**DEPARTMENT OF FORESTRY AND FIRE PROTECTION**

June 18, 2014

**Subject: Comments on a Revised Strategy for the Total Maximum Daily Load (TMDL) for the Upper Elk River**

**Figure 1.** Relative contribution of management versus natural sediment sources to total sediment load time-weighted over the analysis period. Calculated from data in Table 1. Data labels include the estimated load in t mi<sup>-2</sup> yr<sup>-1</sup> and the load percentage, respectively.

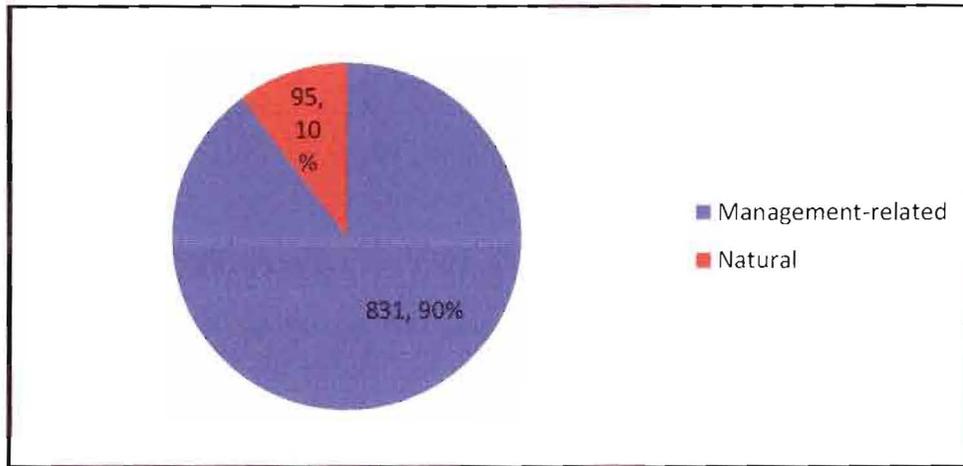
The assumption that a 75% reduction in sediment loading is achievable is rooted in the sediment source analysis in the Peer Review Draft (Table 1). When using a time weighted average over the analysis period, this table indicates that management is responsible for 90% of the total sediment load. Hence, a 75% reduction is theoretically possible (Figure 1). However, as mentioned in our previous comments, the sediment source analysis has fundamental errors in its assumptions that underestimate sources of natural erosion and overestimate sources of management-related erosion. For example, the sediment source analysis assumes that management increased the magnitude of streamside landsliding by a factor of seven over the analysis period, despite the fact that inner gorge landsliding is a well-noted naturally occurring geomorphic process in the northern part of the Coast Ranges province, and is strongly tied to tectonic, lithologic, and climatic conditions (i.e., storm events) (Kelsey, 1988). Also, data from regional studies suggest that the Peer Review Draft's estimates of watershed averaged loading rates from deep-seated landsliding are underestimated by two to three orders of magnitude.

1. Revisit the sediment source analysis before committing to a 75% sediment load reduction. If this is unavoidable, treat the 75% reduction as a “soft” versus “hard” target to be adjusted iteratively through adaptive management.
2. Regardless of the sediment reduction target chosen, assess the feasibility of achieving the target through various approaches (i.e., active and/or passive), along with the uncertainty for each approach.
3. Explore uncertainties with the HST model before validating the sediment reduction target.
4. If necessary, model a more realistic sediment load reduction target with the HST model to determine if desired outcomes are achieved.

**Figure 2.** Relative contribution of management versus natural sediment sources to total sediment load time-weighted over the analysis period. Calculated from modified data in Table 2. Data labels include the estimated load in  $t\ mi^{-2}\ yr^{-1}$  and the load percentage, respectively.

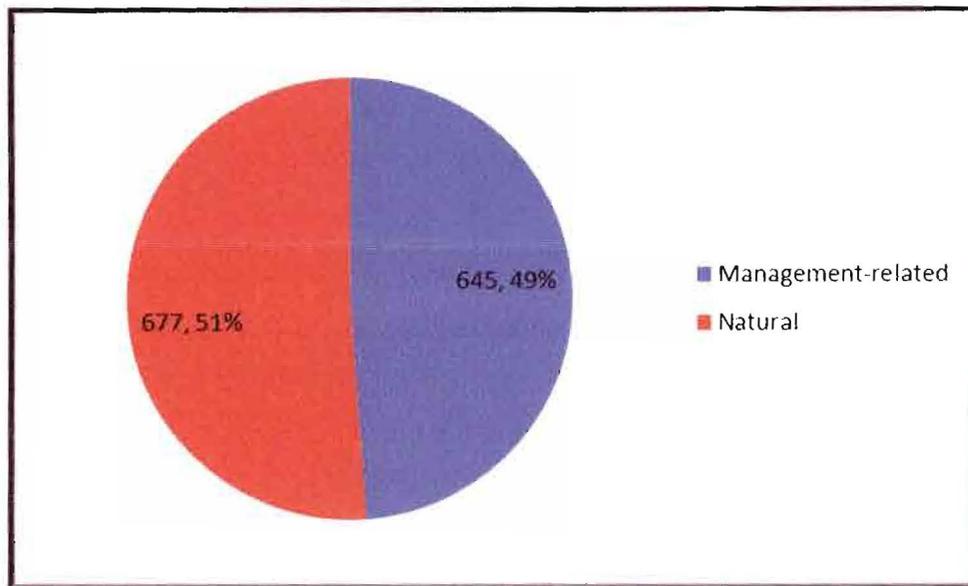
If a more appropriate partitioning between natural and management sources is done, the achievability of a 75% sediment load reduction is called into question. Humboldt Redwood Company's (2014) revised Watershed Analysis suggests a more realistic partitioning by assuming that management contributes 30-40 percent of the combined load due to streamside landsliding and bank erosion (Table 2). The adjustment in streamside landsliding/bank erosion rates, along with increasing the natural loading rate due to deep-seated landsliding from 4 to 400 t mi<sup>-2</sup> yr<sup>-1</sup> (i.e., a two-orders of magnitude increase), brings the natural loading rates to a time-weighted average of 677 t mi<sup>-2</sup> yr<sup>-1</sup> (see yellow highlighted numbers in Table 2). This is within the range of calculated denudation rates estimated by Stallman (2003), and much less than the rates discussed in our previous comments. Due to this modification, the ratio of managed to natural sediment sources drops to the point where only a 50% reduction is theoretically possible (Figure 2).

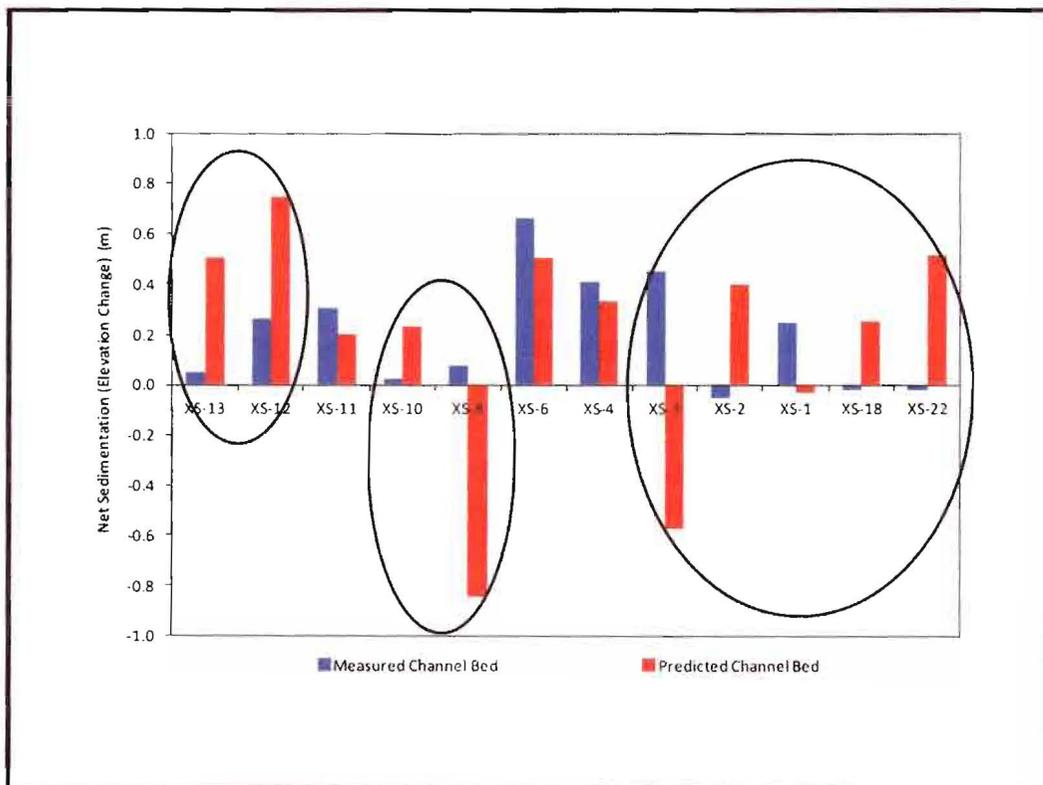
The HST model does an adequate job predicting water surface elevations and flow velocity, but does a poorer job predicting sedimentation at smaller spatial scales (i.e., DEM grid scale). In many cases the model over or underpredicts by more than a factor of two or three, and also predicts in the wrong direction (i.e., scour versus deposition and vice versa) (Figure 3). The modeling report (Appendix 3D) states the following regarding this issue:

While reach-averaged predictions show better agreement with observed data, it is cause for concern that the model does not more accurately predict the general pattern of sedimentation at smaller spatial scales. Localized nuisance flooding is strongly controlled by sub-reach conditions, and the predictions made by the model (i.e., net scour with a 75% sediment load reduction) may not manifest itself in reduced nuisance flooding. Additional work needs to be done to determine if the noted model errors (i.e., high and low spikes associated with meanders) are driving the reach-averaged predictions. As mentioned in the previous section, CAL FIRE believes that a 75% reduction is infeasible given the hydrogeomorphic conditions operating in the watershed. Therefore a more realistic sediment load reduction should be modeled to determine if the desired outcome is achieved.
